Construction Documentation Report

Landfill Gas Collection and Control System Expansion 2011

Johnston County Landfill (Permit# 51-03)

I have completed a review of the revised Construction Document Report (Report). There are several “typos” or data missing in the As-built drawings which are described below:

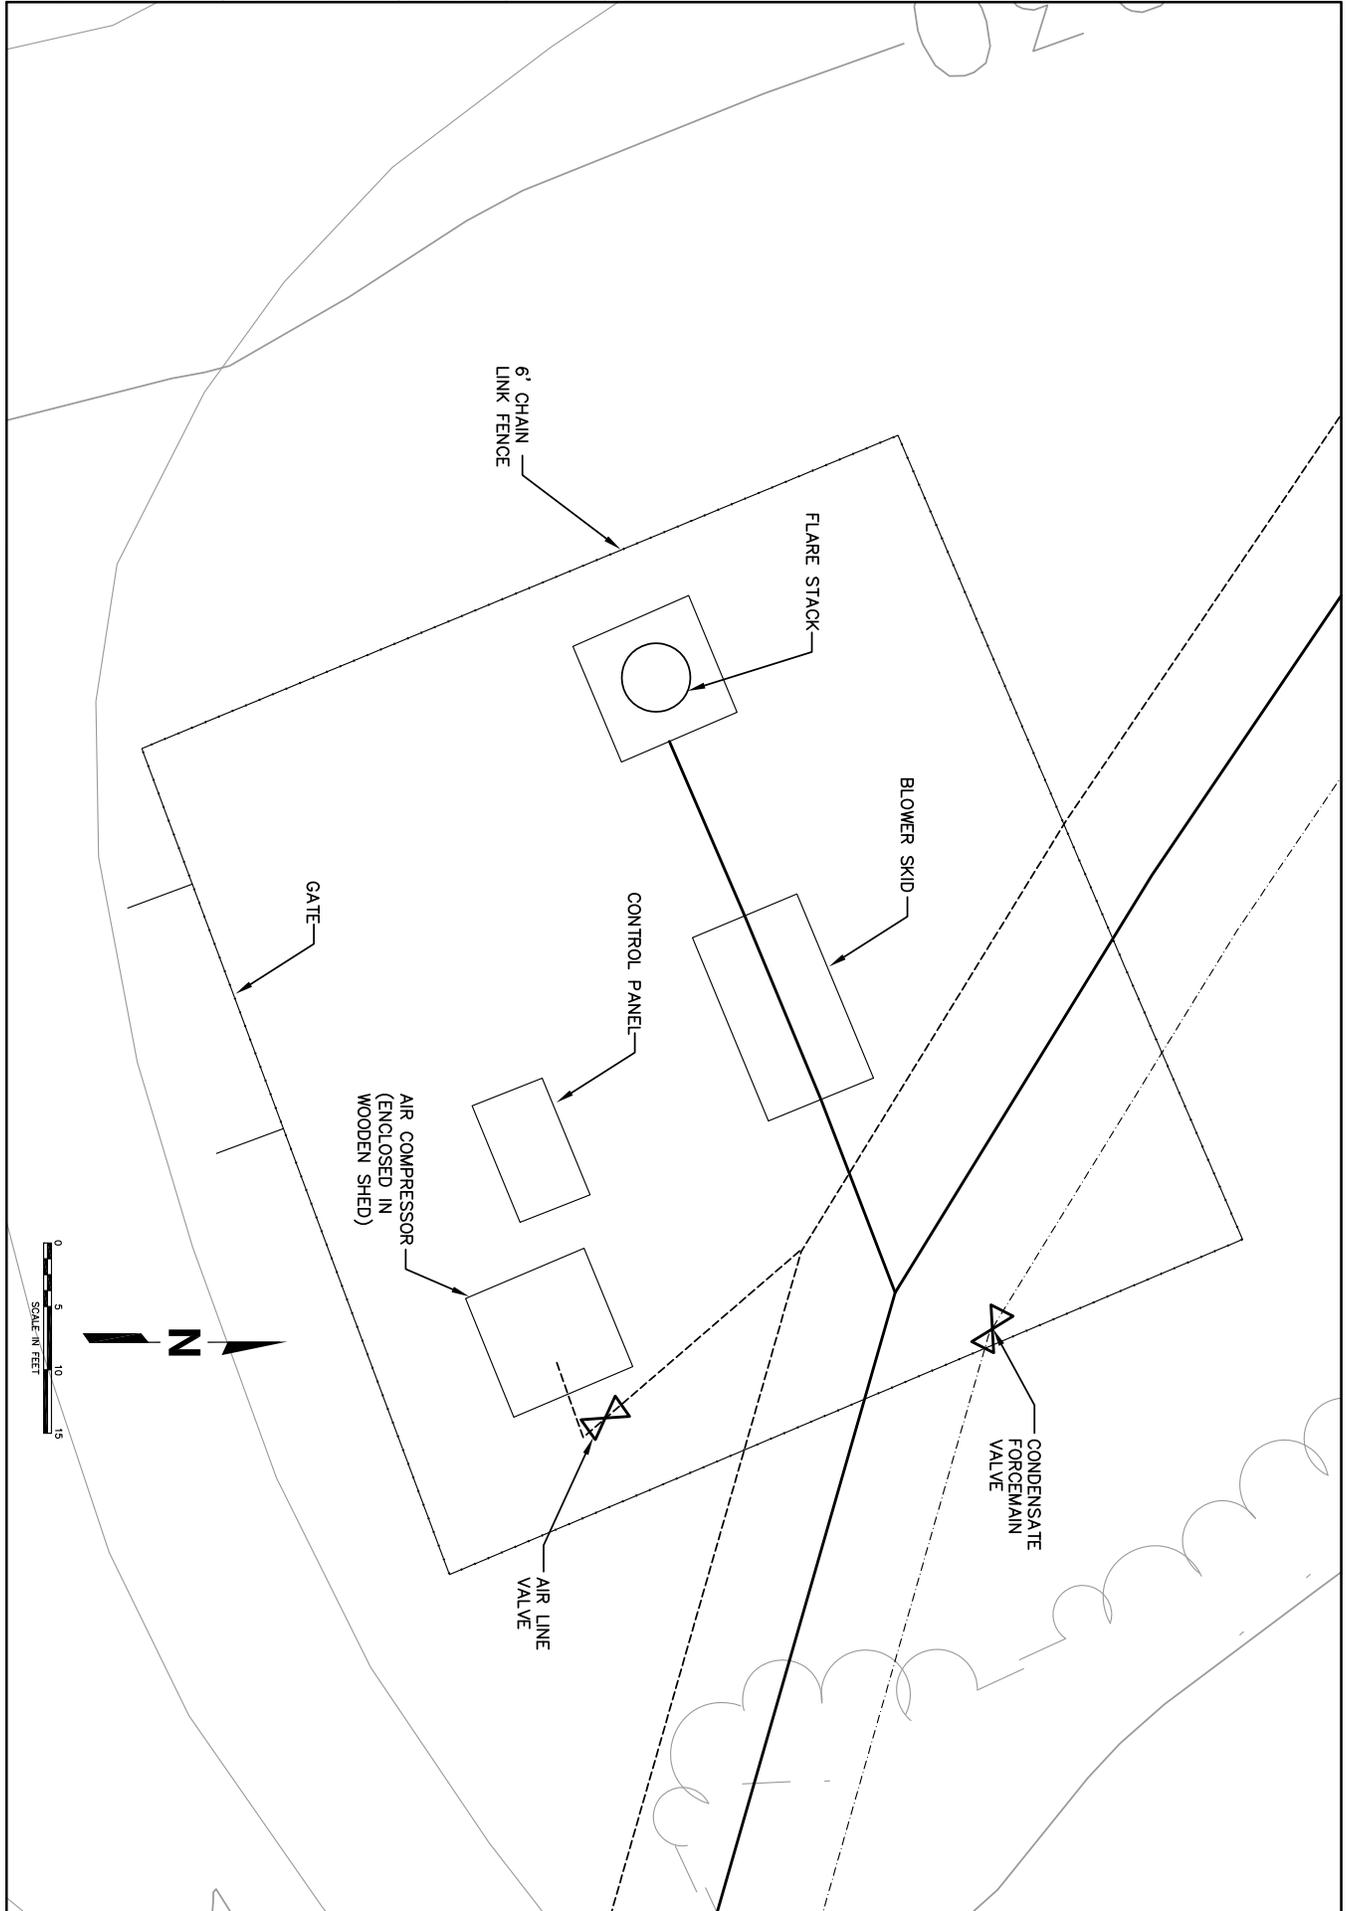
6. (Appendix D – Record Drawing No. 1 of 1)
 - i. The as-built drawing must be signed and sealed by a professional engineer or licensed surveyor registered in the State of North Carolina.

- ii. Please provide the final well schedule (tabulated format) in consistent with the well logs on the as-built drawing. For example final data of the ground elevation, well depth, etc is based on survey results. Well EW-417 is removed from the project scope. Since many wells are relocated in the field, so the final northing & easting coordinates of these well must be provided in the record report.

- Comment 6.i. was addressed by including the licensed surveyor's signed and sealed drawings as part of Appendix F.
- Comment 6.ii. was addressed by adding an as-built well schedule (tabulated format) in Appendix D and revising Appendix C.
- Comment 7 was addressed by revising Section 2.1 of the report.
- Comment 8 was addressed by adding Appendix J to the report.
- Comment 9 was addressed in a phone call between Steve Lamb of SCS and Mr. Chao where Mr. Chao was informed that Johnston County retained another consultant, RSG and Associates, to revise the Operations Plan and Closure and Post-Closure Plan for the site.

DATE: 12-2-11
SCALE: N.T.S.
DRAWN: RDM
CHECKED: MWY
SHEET: 12 of 12
CAD FILE: ASBUILTS.DWG
PROJECT NO: 110065

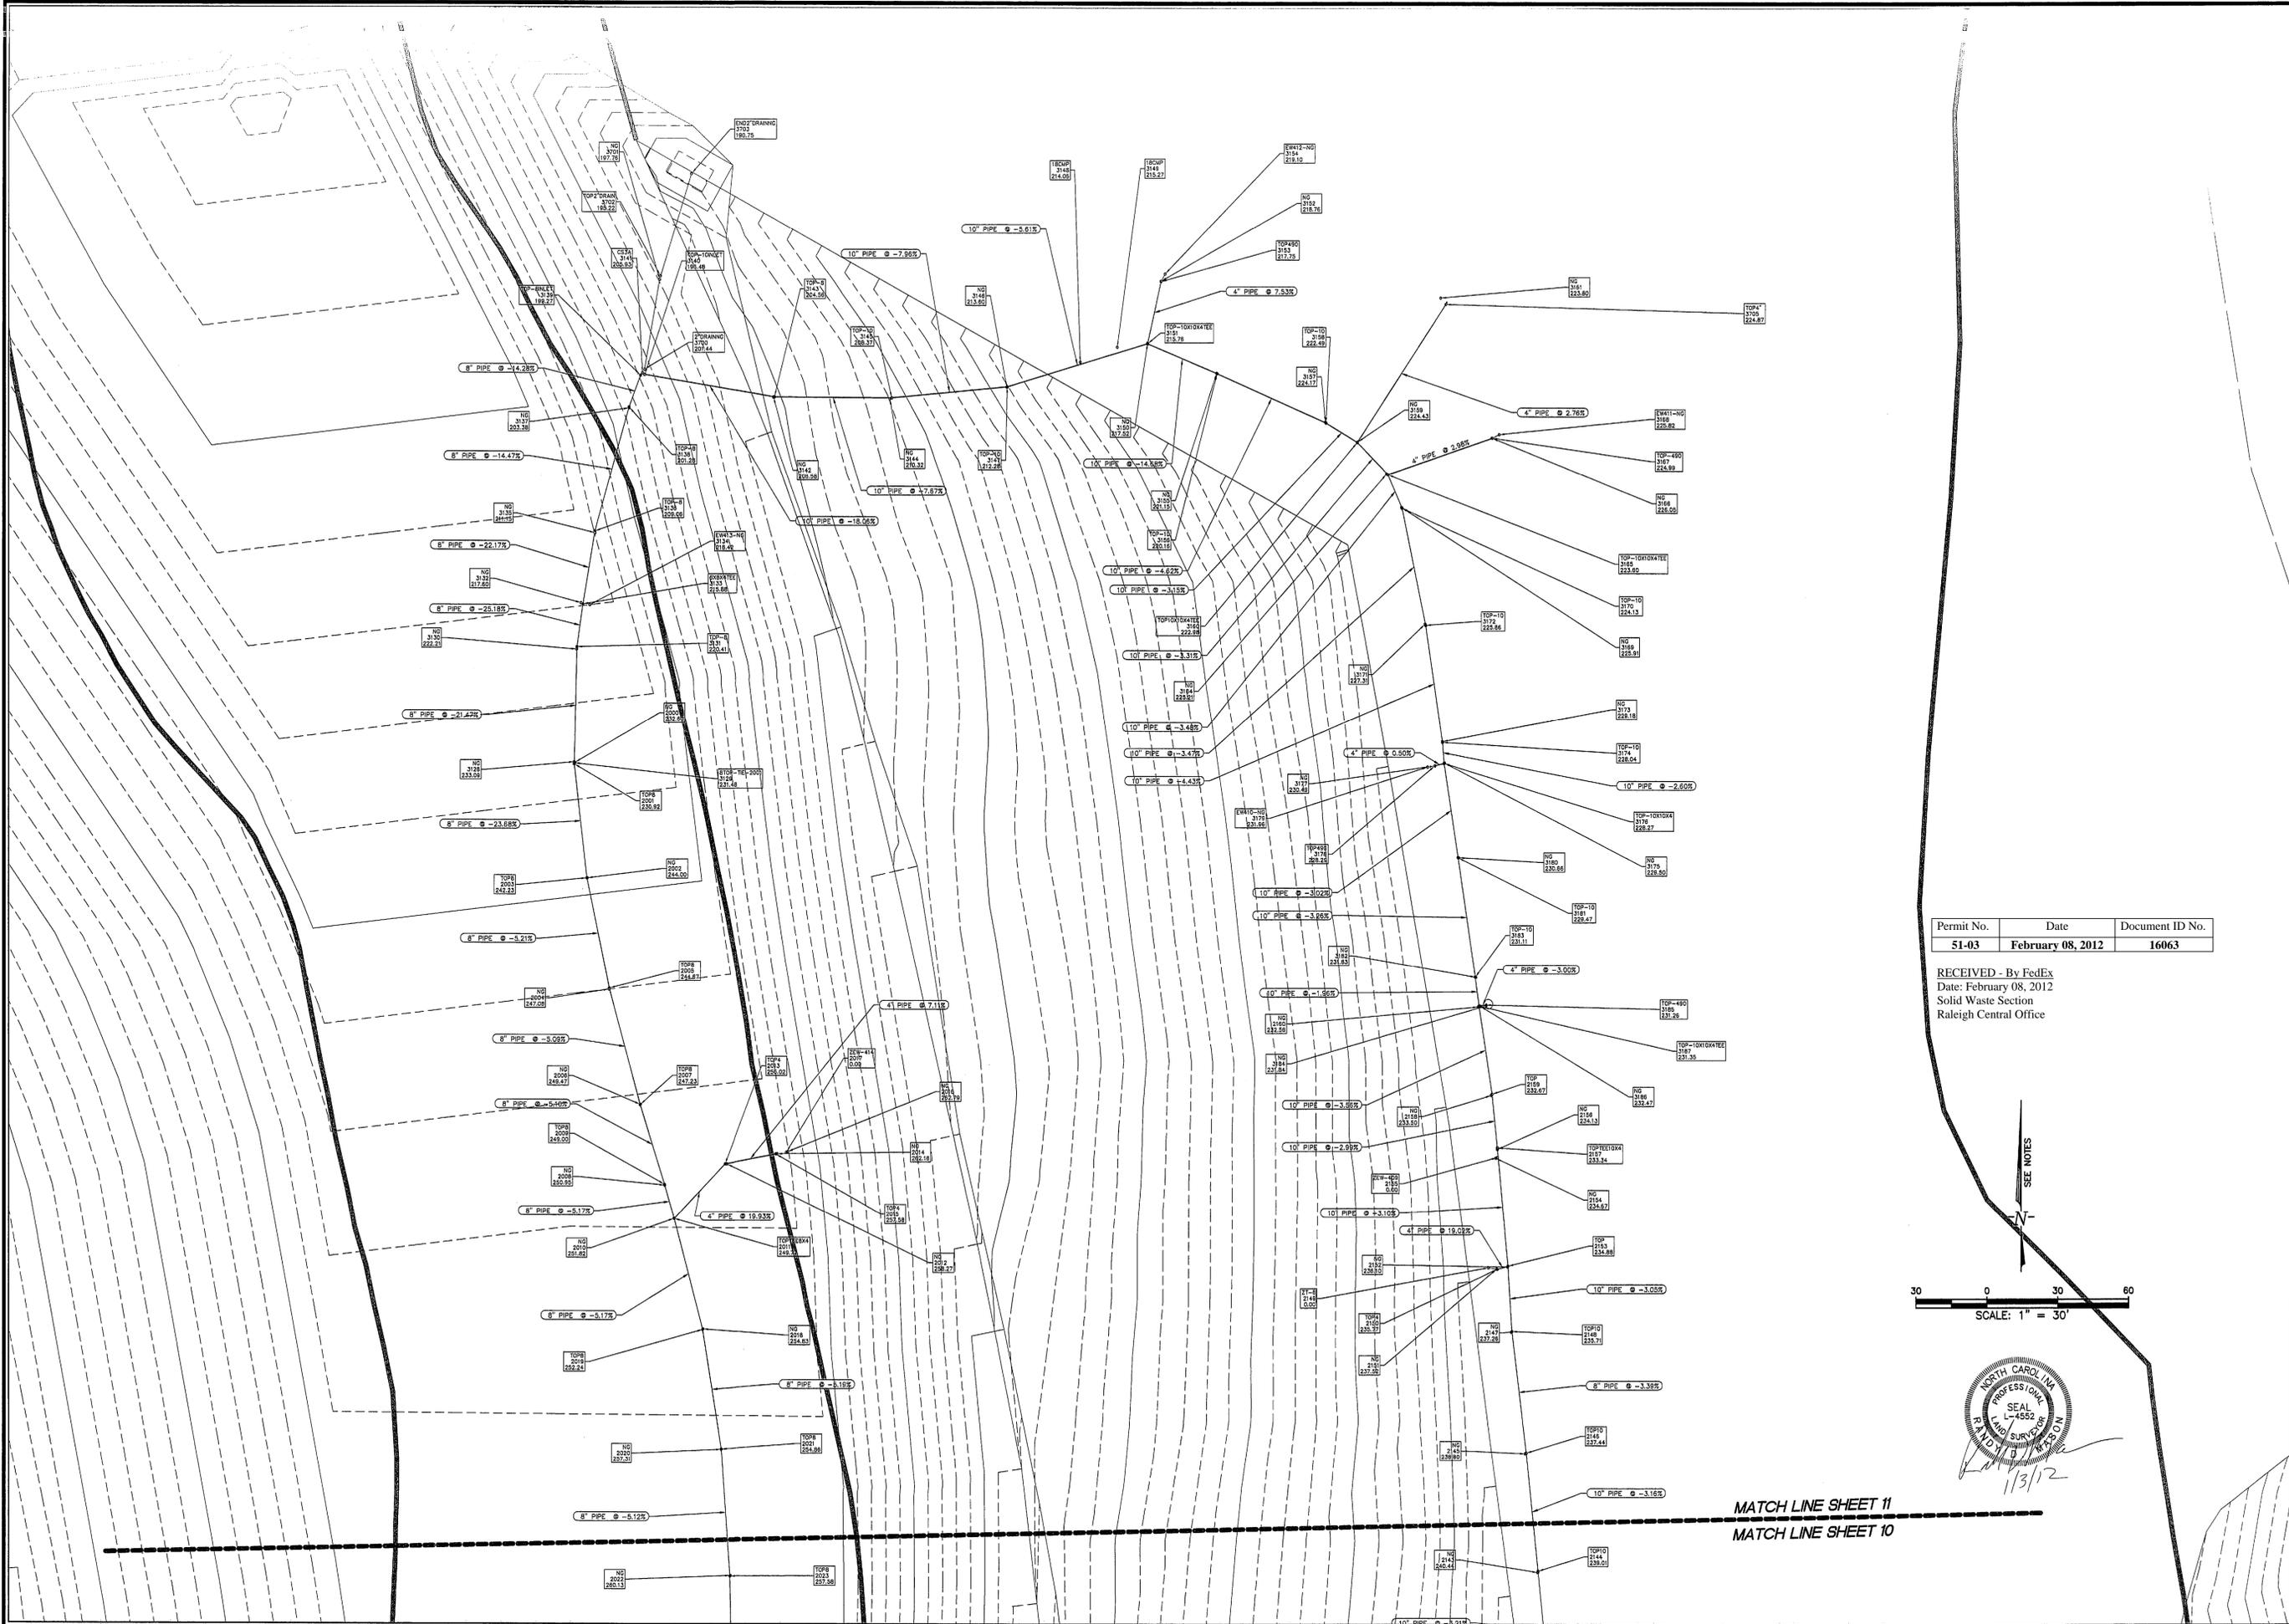
4. (Sheet 12 of 12) Please incorporate the responses to the comments No. 1 through 3 to the data sheet on the drawing.
5. Appendix D – As-built Well Schedule Table
